**Addendum No. 1  
September 27, 2021**

Project: **Harrisburg Middle School No. 3**  
Harrisburg, South Dakota  
Architecture Incorporated Project #2903

Architect: Architecture Incorporated

FLOOR PLAN - AREA B - VENTILATION & A/C

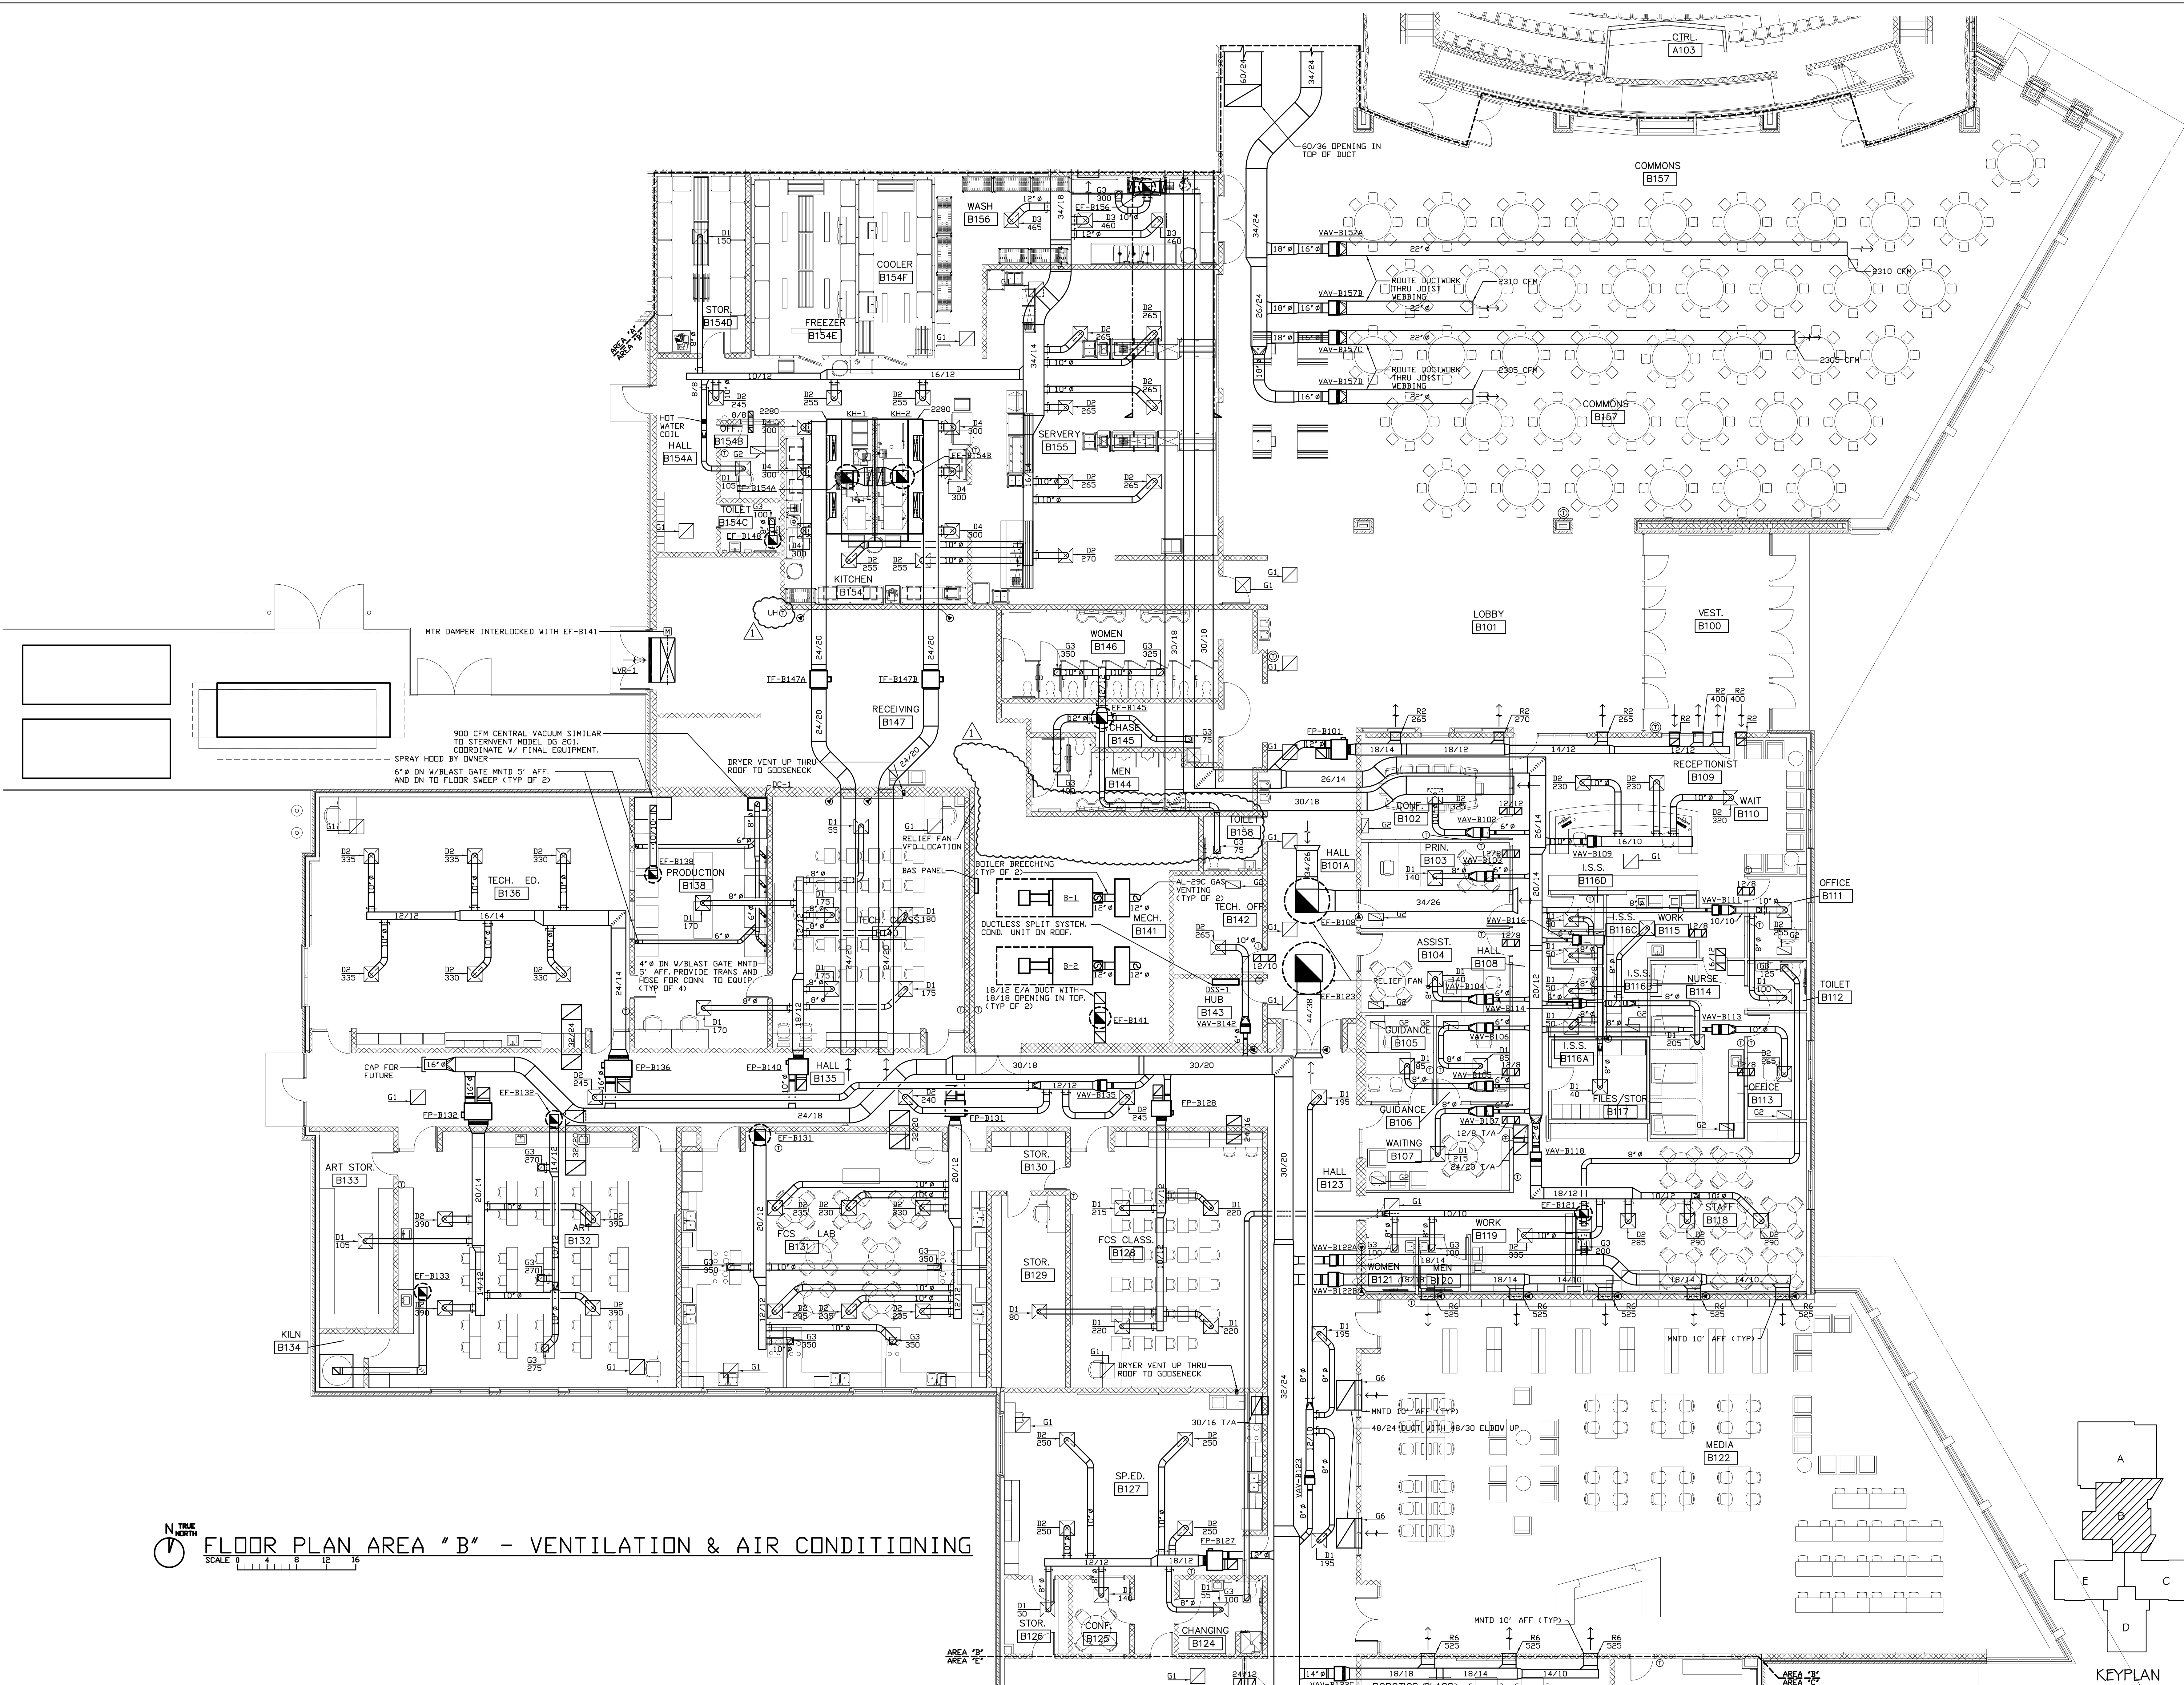
- a) Refer to revised mechanical drawing Sheet 8.51, revision dated 9-27-21, attached to the end of Addendum #1 for the following:
  - i) Delete IH-B141, associated ductwork, and motorized damper.
  - ii) Relocate UH-B147 thermostat.
  - iii) Revise exhaust ductwork routing to “Toilet B158” to avoid fire rated walls.
